City of Lone Tree Planning Commission Agenda Tuesday, February 23, 2016

TO: City of Lone Tree Planning Commission

Approval of a Site Improvement Plan (SIP) amendment for a two-story, 20,000-square-foot, mixed-use building designed for space above flexible retail and restaurant tenant space, on a 1.01 acre extent-of-work area in the master-planned, Lincoln District East portion of the Lincoln Commons development.

Project Name and File Number:	RidgeGate Sec. 15, Fil 5 2 nd Amdt, Lot 1-F1
Project Type:	SIP Application for 20,000 square-foot, mixed-use, office building
Comments Due By:	February 15, 2016 SP15-99R
If you are unable to respond by the due date, please contact the project planner

4 REAR (SOUTH) ELEVATION
 SCALE: 1/8" = 1'-0"

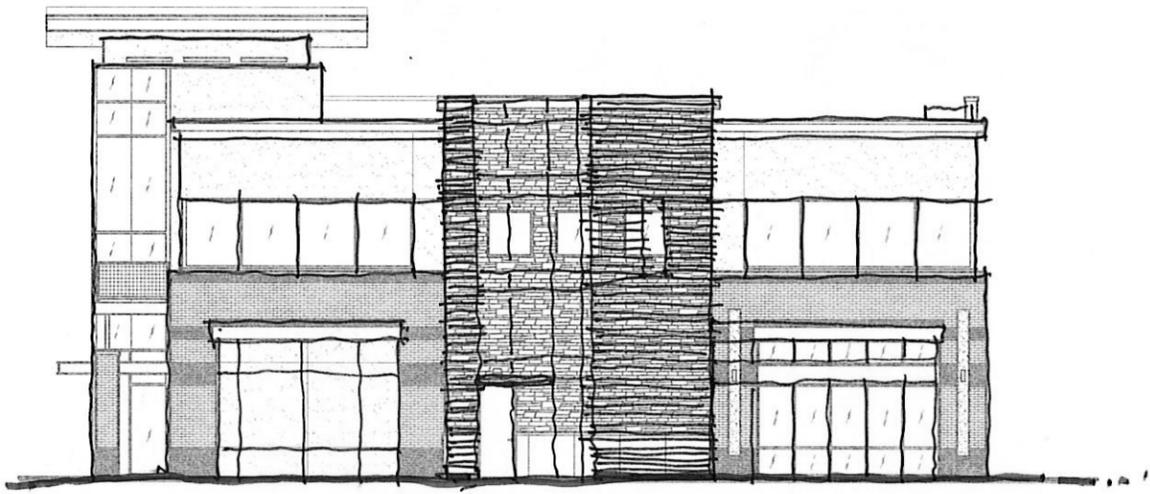
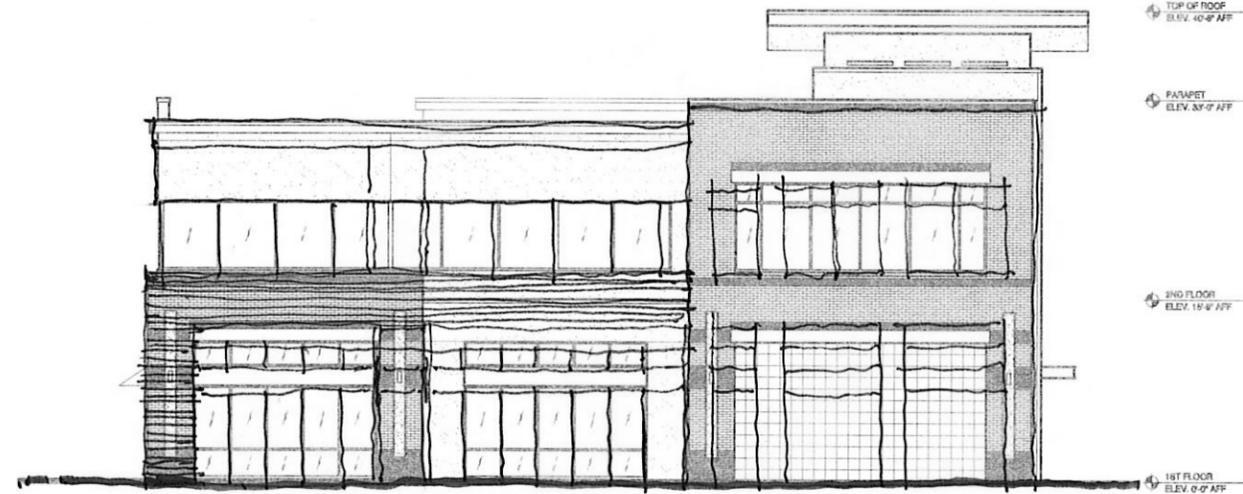
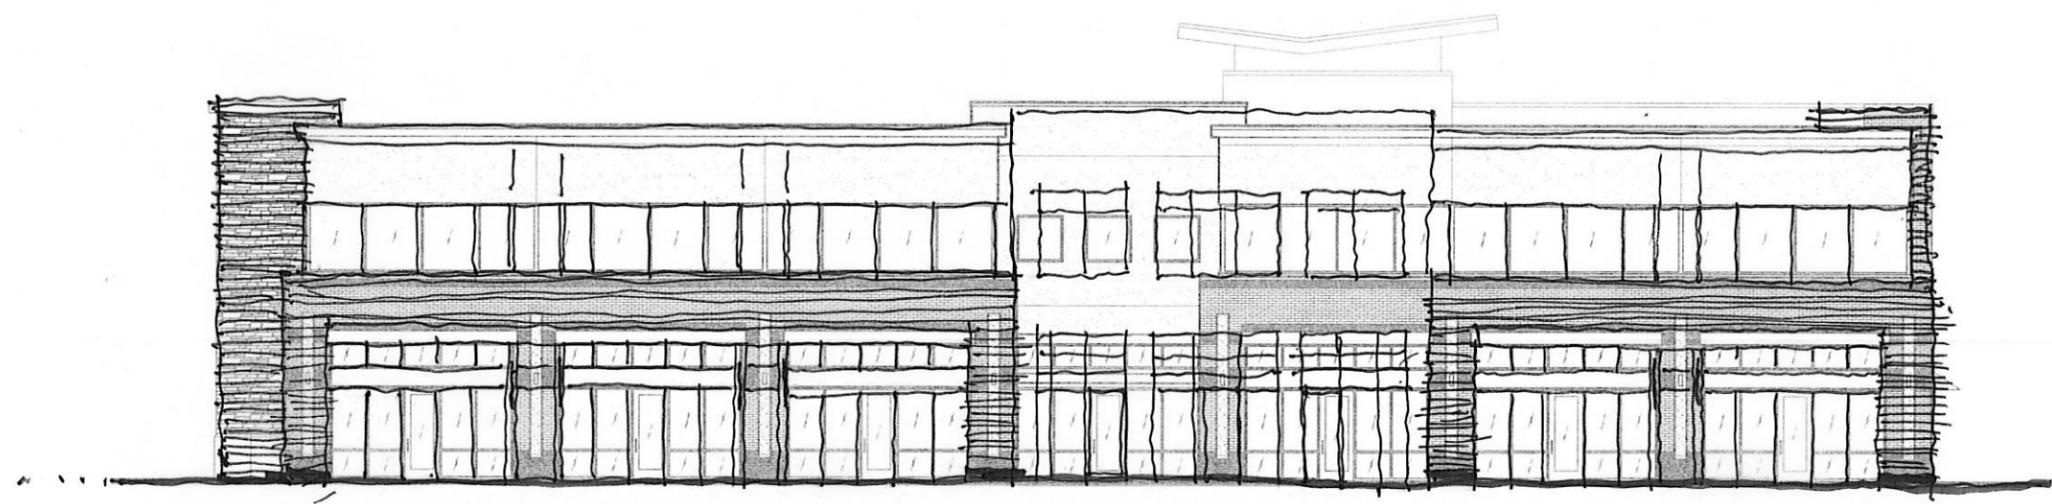
1. Consider alternatives to the green screen on the south elevation, such as a solid masonry wall or a combination of a wall and screen.
2. Wrap the steel trellis detail around the southwest corner.

3. Consider eliminating the tile wall detail on the west side at the southwest corner.
4. Consider increasing brick up the office entry tower, leaving only glass in the middle and at the top. Consider illuminating the top.

5. Delete the roof detail of the office entry tower.
6. Extend the added brick details/patterning on the southwest side of the building over 1 bay east of the office entry.

7. Lighten up the east stair element and simplify it as well as the rest of the building and use a fewer number of exterior materials.
8. On the retail north elevation, increase the “green” detail by one bay and pop the detail out rather than recessing it.

9. Screen mechanical equipment on the roof.
10. On the east side of the building, eliminate the planting beds that abut the building and make them hardscape.

COVER SHEET
 LINCOLN DISTRICT EAST
 CITY OF LONE TREE
 DOUGLAS COUNTY, COLORADO

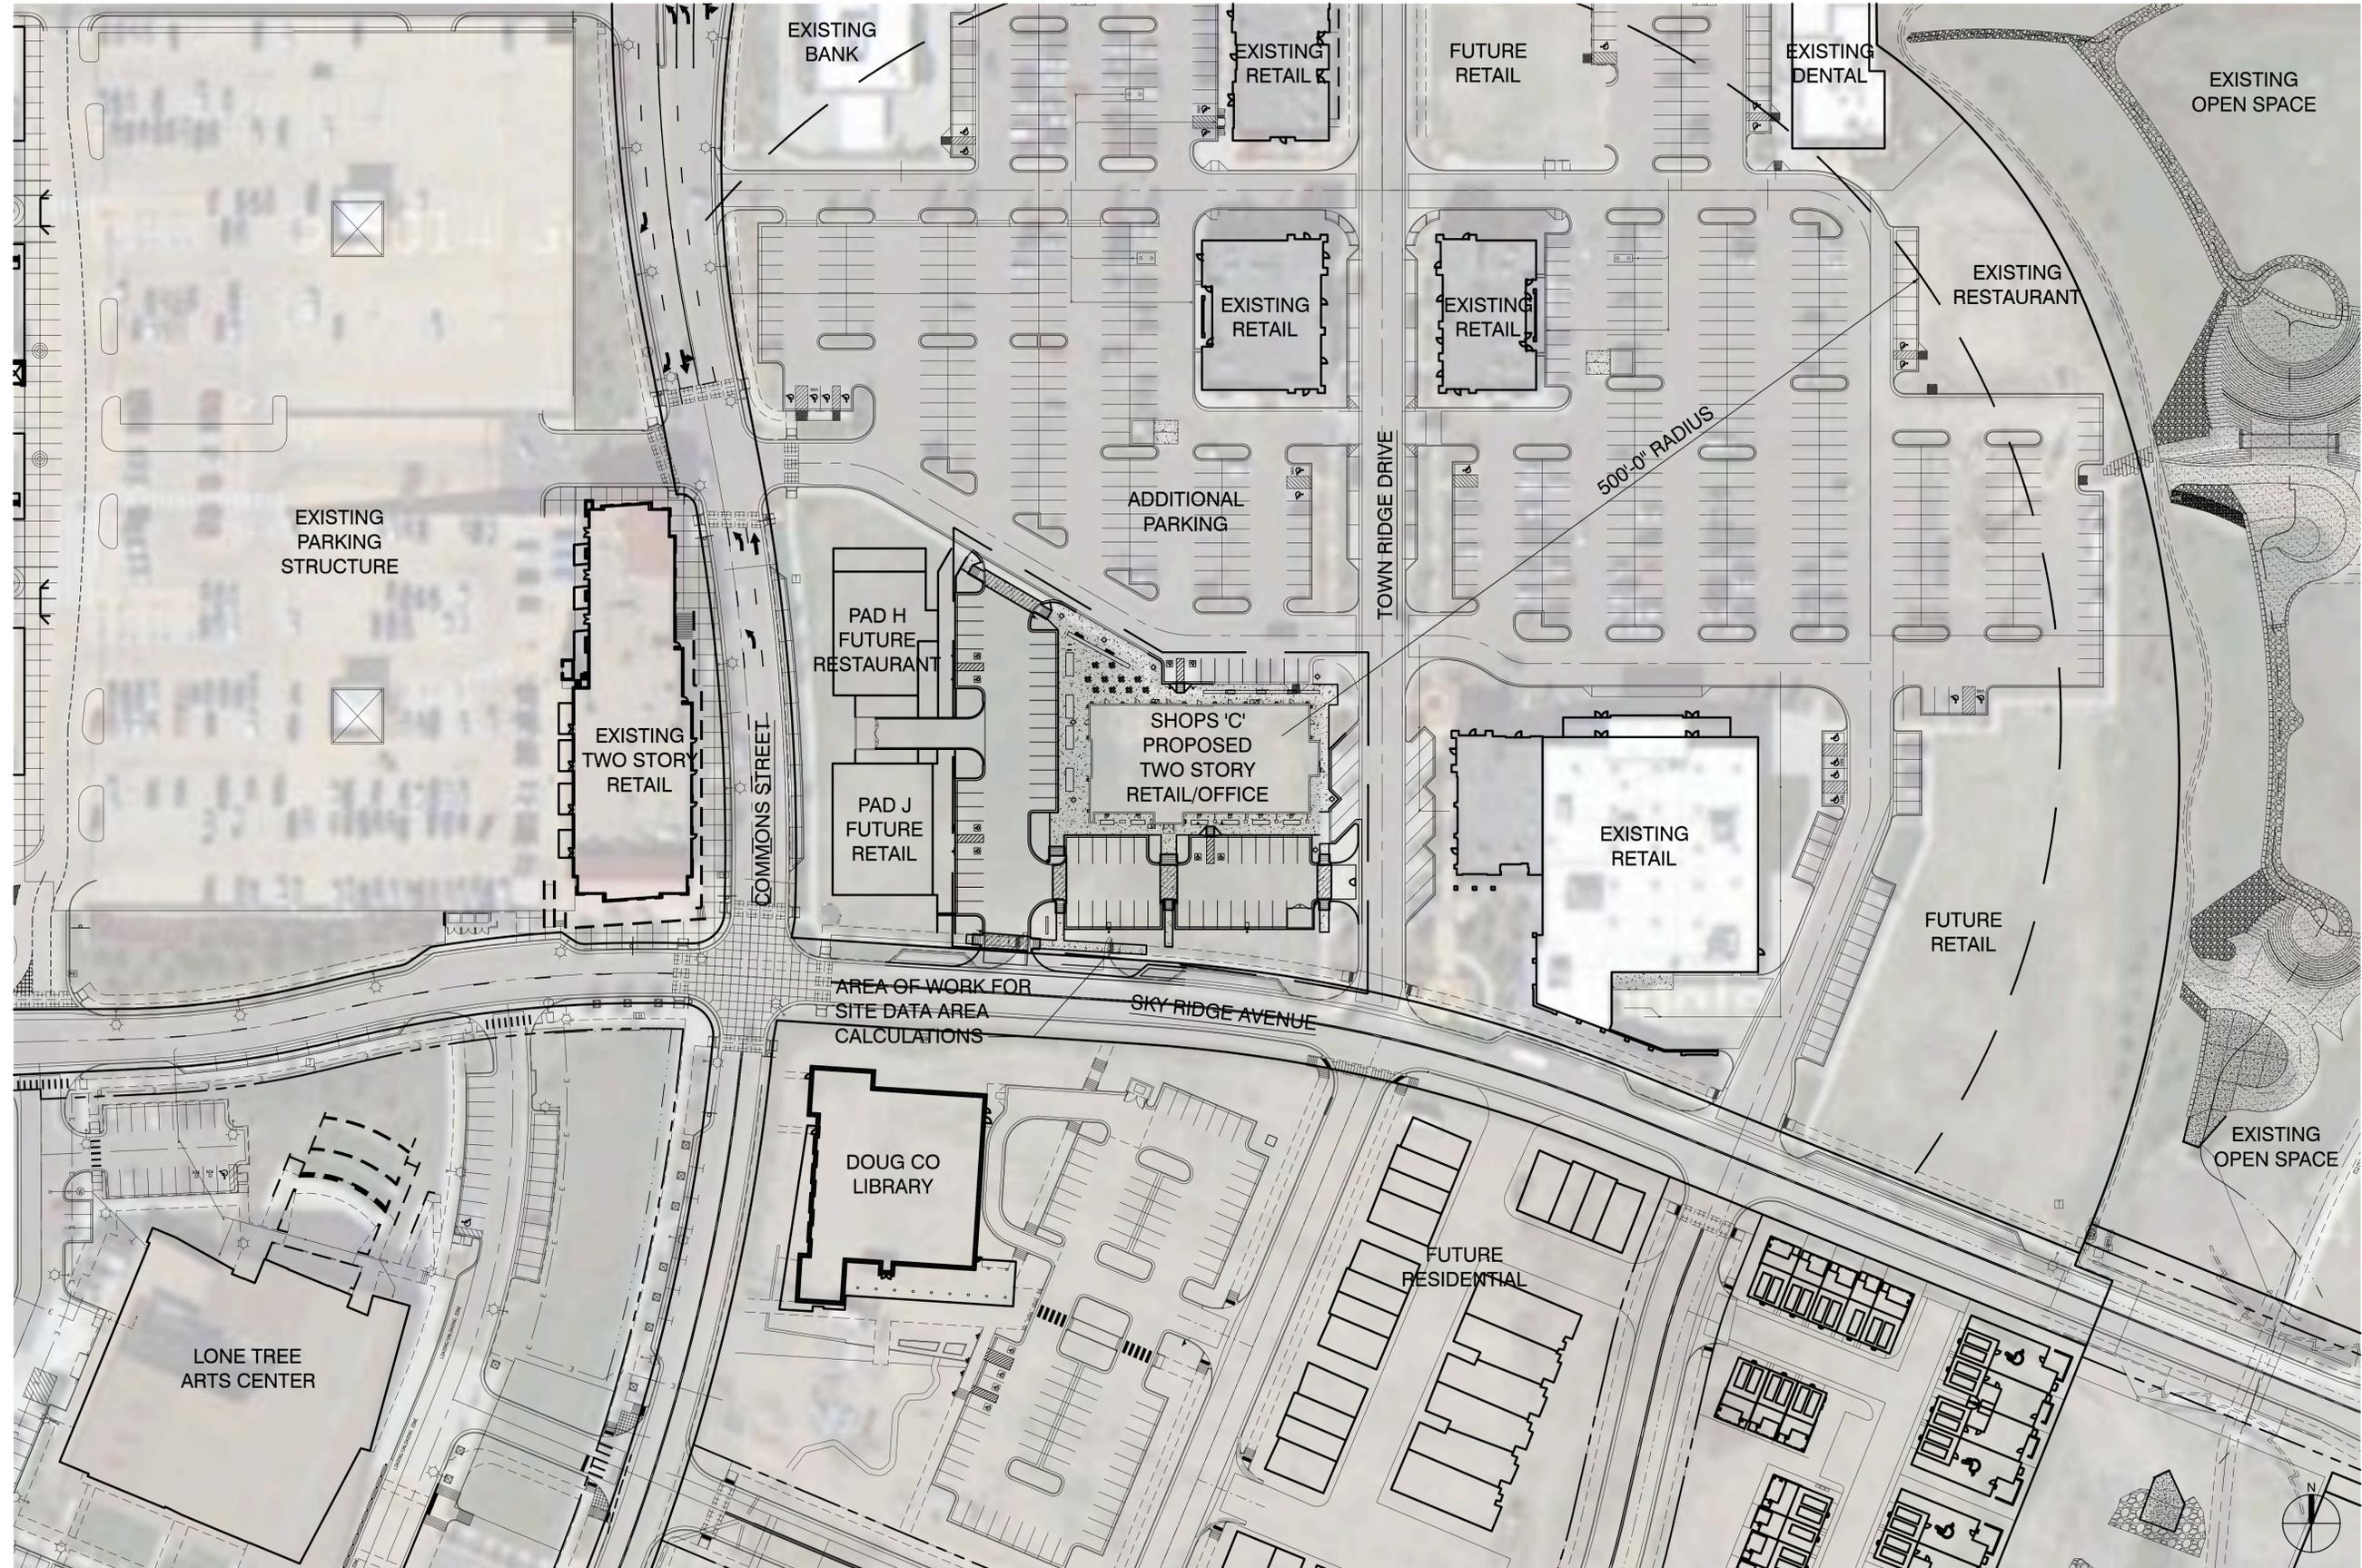
Sheet 1 – Cover Sheet:

1. The areas of the site breakdown (e.g. Bldg. Footprint + Parking/Paving+ etc. = 30.907 sf) does not total up to equal the total gross area of the site (44,097 sf).
2. The Parking data summaries do not appear to be consistent and/or to meet requirements:
 - a. Site Data suggests 100 spaces required and >100 spaces provided.
 - b. Parking Demand listing indicates 116 spaces required.
 - c. Shared Parking Analysis seems to indicate 100 spaces (peak) requirement.
 - d. Parking Summary on Sheet 3 – Site Layout Plan indicates 72 space provided.

- d. Parking Summary on Sheet 3 - Site Layout Plan indicates 72 space provided
 - ***The parking required for the mixed use building is 100-spaces as shown in the Shared Parking Analysis" on the cover sheet. The proposal includes 72 spaces immediately adjacent to the building, and additional parking is provided by the surplus of spaces in the field to the north. The current approved SIP indicates all parking for buildings in this area would be provided to the north, and our proposal includes additional parking closer to the building.***

SITE LAYOUT PLAN
 LINCOLN DISTRICT EAST
 CITY of LONE TREE
 DOUGLAS COUNTY, COLORADO

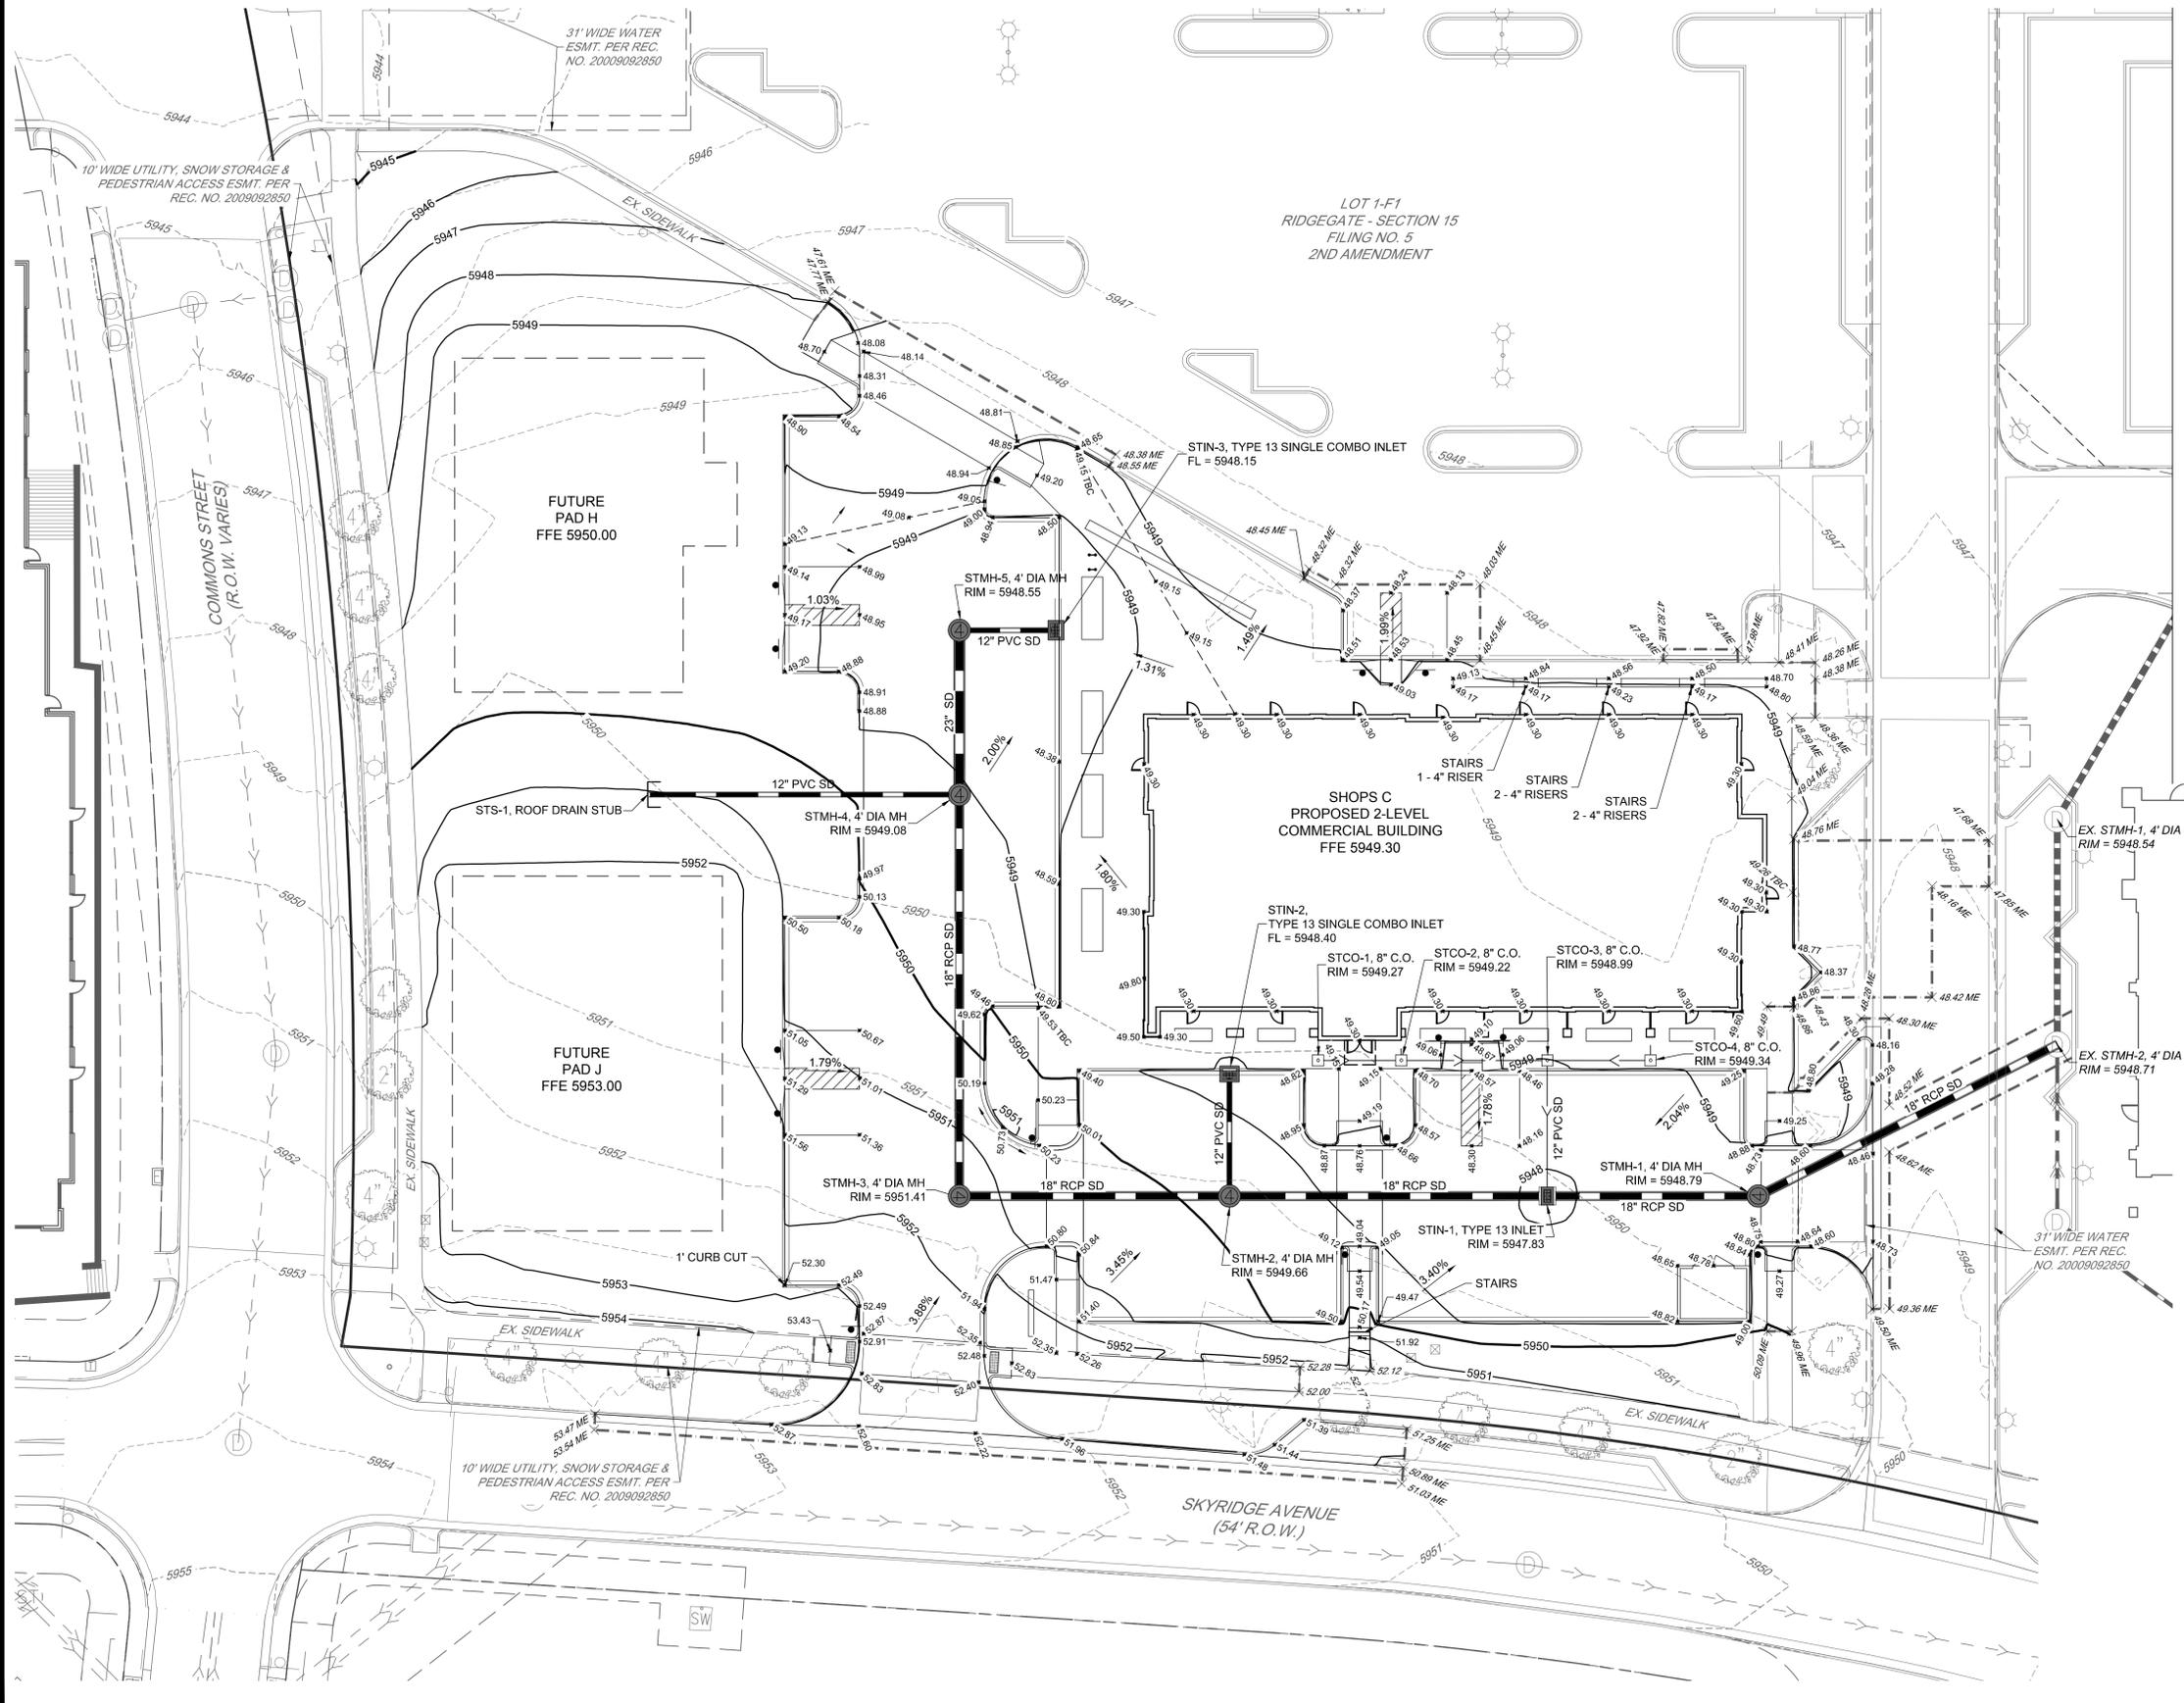
Sheet 3 – Site Layout Plan

4. It should be noted that the existing sidewalks across the west (Commons Street) side and the south (Sky Ridge Avenue) side of the Project site are located on the Project site, outside of the associated street ROW's. Accordingly, these sidewalks, and their maintenance, are the responsibility of the Property Owner, and not the City. An appropriate note acknowledging this condition should be added to both the Cover Sheet and Sheet 3 of this SIP submittal.

- ***The ADA ramp has been changed to a "type 2" ramp to provide proper circulation adjacent to the building.***
4. It should be noted that the existing sidewalks across the west (Commons Street) side and the south (Sky Ridge Avenue) side of the Project site are located on the Project site, outside of the associated street ROW's. Accordingly, these sidewalks, and their maintenance, are the responsibility of the Property Owner, and not the City. An appropriate note acknowledging this condition should be added to both the Cover Sheet and Sheet 3 of this SIP submittal.
